DART SERVICE INSTRUCTION

TO AMEND INSTALLATION INSTRUCTIONS IIN-D205-594 Rev. C (AND EARLIER) AND
INSTRUCTIONS FOR CONTINUED AIRWORTHINESS ICA-D205-594 Rev. 2 (AND EARLIER)
REF. CANADIAN STC: SH03-6
REF. FAA STC: SR01742NY

A	NEW ISSUE	MB	07.11.16
REV.	DESCRIPTION	BY	DATE
DESIGN		DART AEROSPACE LTD HAWKESBURY, ONTARIO, CANADA	
DRAWN			
CHECKED		DRAWING NO.	REV. A
MFG. APPR.		DSI 9396	SHEET 1 OF 2
APPROVED		TITLE	SCALE
DE APPR.		CROSSTUBE SUPPORT CHANGE	NTS
DATE	07.11.16	COPYRIGHT © 2007 BY DART AEROSPACE LTD THIS DOCUMENT IS PRIVATE AND CONFIDENTIAL AND IS SUPPLIED ON THE EXPRESS CONDITION THAT IT IS NOT TO BE USED FOR ANY PURPOSE OR COPIED OR COMMUNICATED TO ANY OTHER PERSON WITHOUT WRITTEN PERMISSION FROM DART AEROSPACE LTD.

FIGURE 1: INSTALLATION OF SUPPORT ON CROSSTUBE

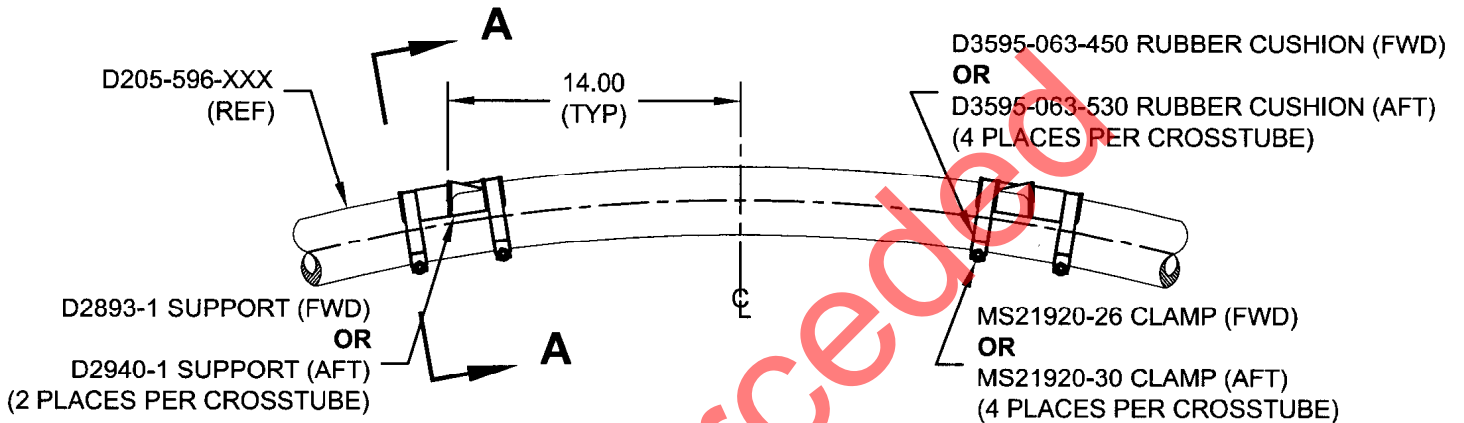
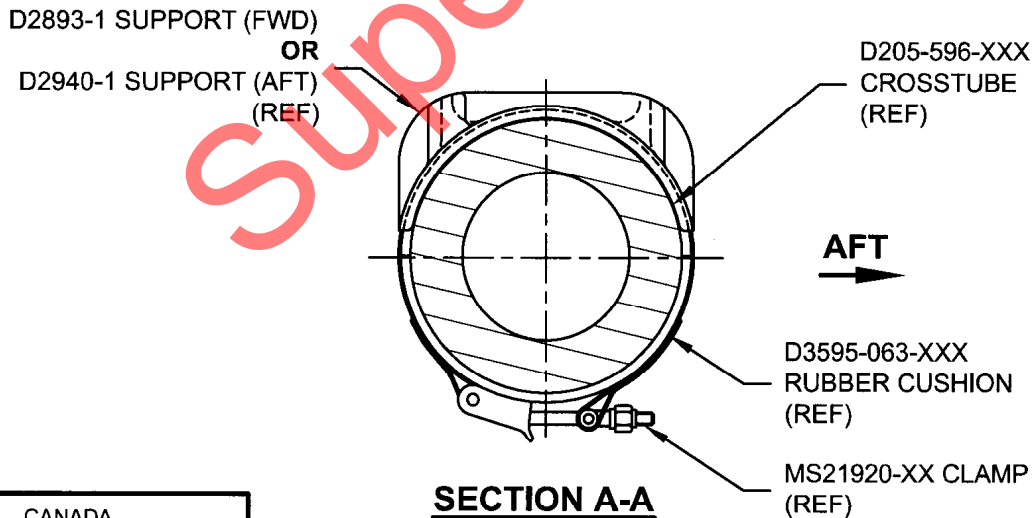
For D205-596-101/-103 Crosstubes (ref. 39" Landing Gear) or D205-596-105/-107 Crosstubes (ref. 31" Landing Gear) at CHG 002 or later, the D2856-600-851/-1009 Abrasion Strips have been removed, the D2893-1 and D2940-1 Supports have been bonded onto the crosstubes using Magnobond 6398 and D3595-063-450/-530 Rubber Cushions have been installed underneath the MS21920-26/-30 Clamps. Amend Parts List of IIN-D205-594 Section 5 and ICA-D205-594 Section 32.8 as follows:

To prevent the supports from shifting on D205-596-101/-103/-105/-107 Crosstubes at CHG 001, the D2893-1 or D2940-1 Supports should be removed and re-installed as follows:

- Apply a 0.03" to 0.06" thick layer of Magnobond 6398 underneath D2893-1 or D2940-1 Supports and re-install the Supports on the crosstube as shown in Figure 1. Install a D3595-063-450/-530 Rubber Cushion on each MS21920-26/-30 Clamp. Position and secure the D2893-1 or D2940-1 Supports on the crosstube using MS21920-26/-30 Clamps. Torque clamps to 80-100 in-lb. Let the D205-596-101/-103/-105/-107 Crosstube Assembly cure before re-installing the crosstube on the aircraft.
